Serial No. 10/770,878

**Amendments to the Drawings:**

REMARKS/ARGUMENTS

# FIGURE 4

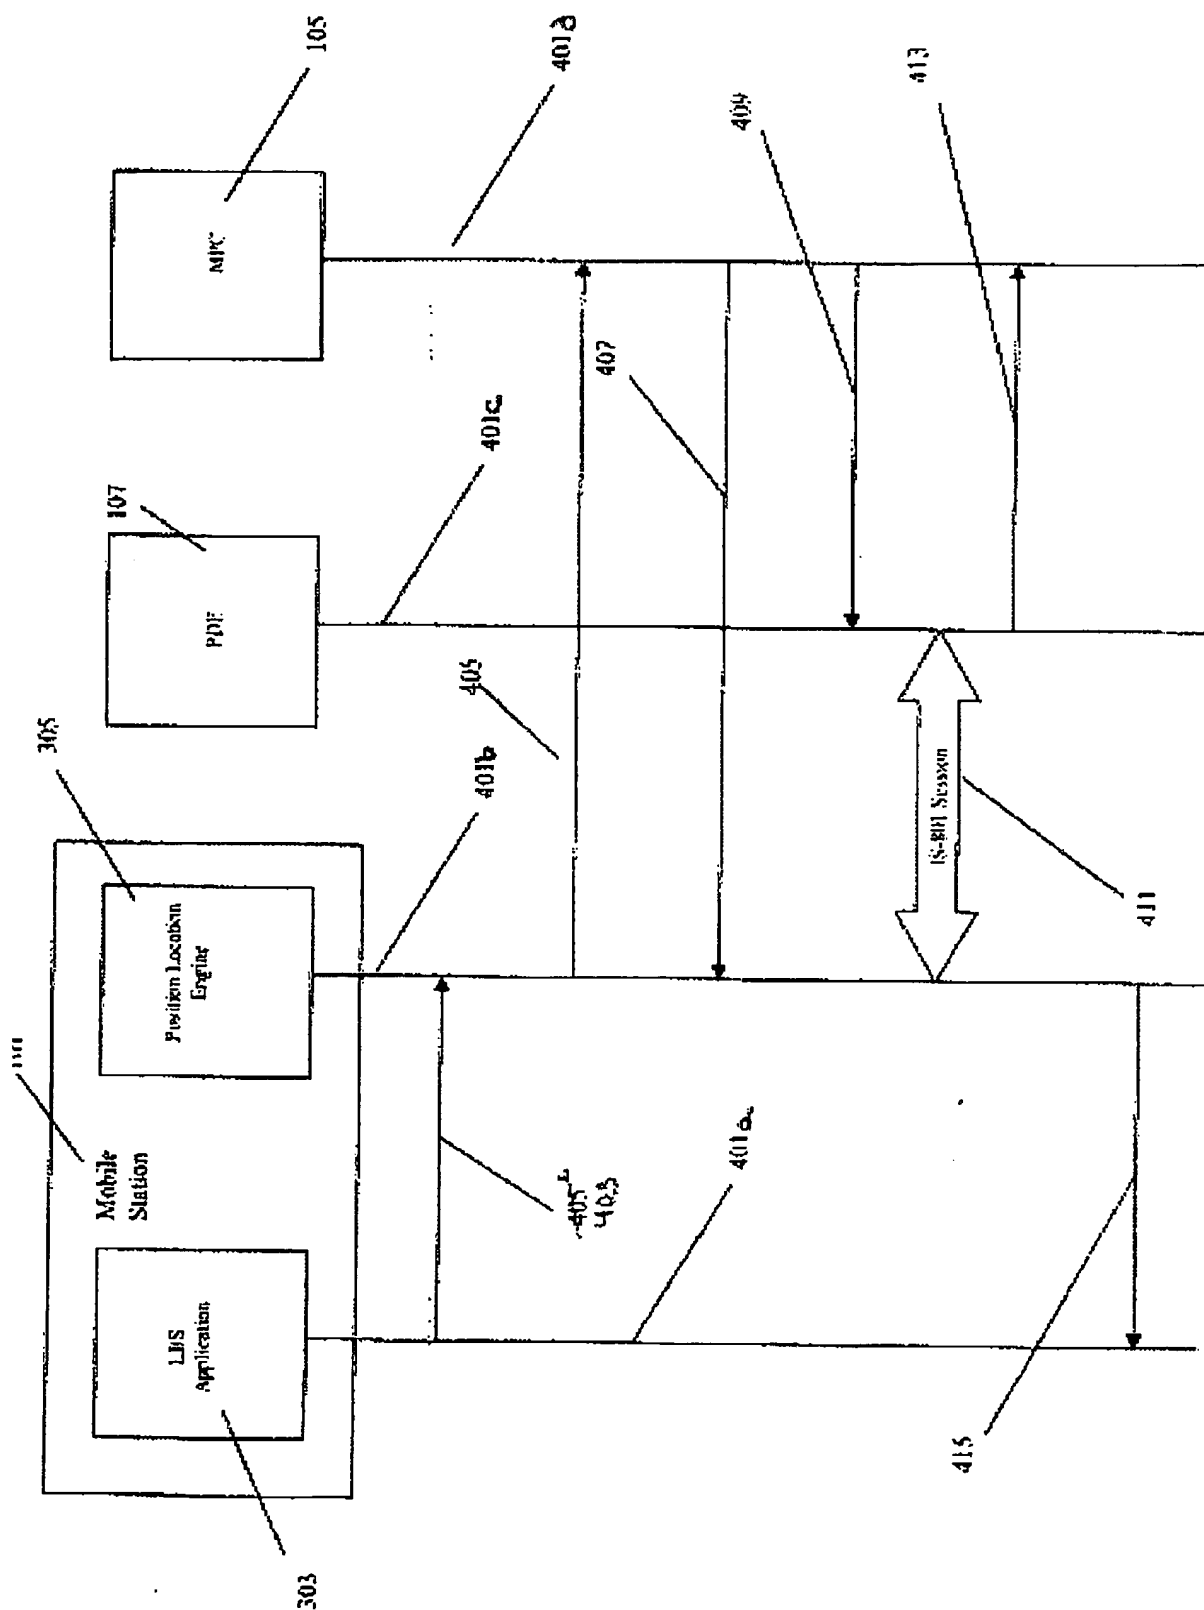
The drawings were objected to for failing to show elements 401a, 401b, 401c, 401d, and 403 in FIGURE 4, as described in the specification.

The attached sheet of drawings includes changes to FIGURE 4. This sheet, which includes FIGURE 4 replaces the original sheet including FIGURE 4.

A separate copy of FIGURE 4 showing redlined changes is attached.

Applicant amends FIGURE 4 to correct the reference designators to correspond to the description at paragraphs [1027] and [1028]. In particular, the four instances of reference numeral "401" were revised to illustrate "401a", "401b", "401c", and "401d". Applicant believes that the specification is clear that reference identifiers 401a, 401b, 401c, and 401d refer to the vertical lines extending from blocks identified, respectively, with 303, 305, 107, and 105. Additionally, the typographic error to the arrow from the LBS application to the Position Location Engine has been changed from "405" to "403" to conform to the specification, at paragraph [1028].
